**Technical Service
BULLETIN**

**REPAIR FOR REAR SEAT VIDEO
DISPLAY SCREEN LATCH MECHANISM**

'03 – '07 Land Cruiser w/RSE

AX007-06
ACCESSORIES

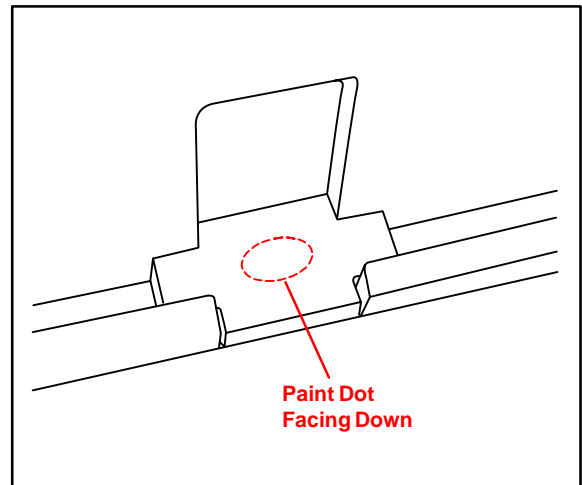
6. Install the small metal shim (P/N PT296–60062–SK), with the paint dot facing down, into the shroud latch opening. Be sure it is secure.

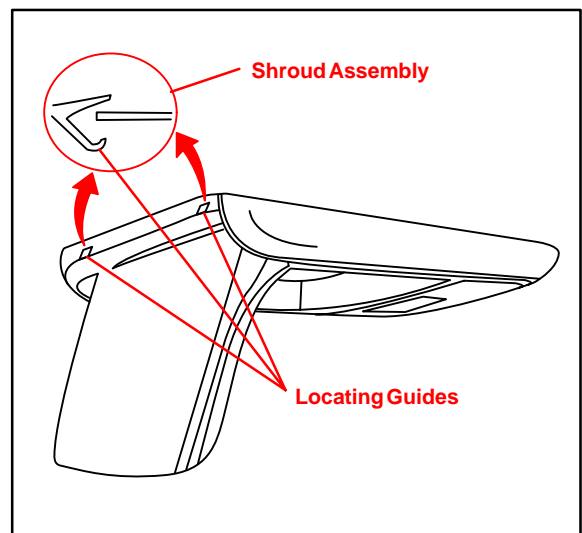
7. Reinstall the shroud cover making sure the locking guides are properly engaged.
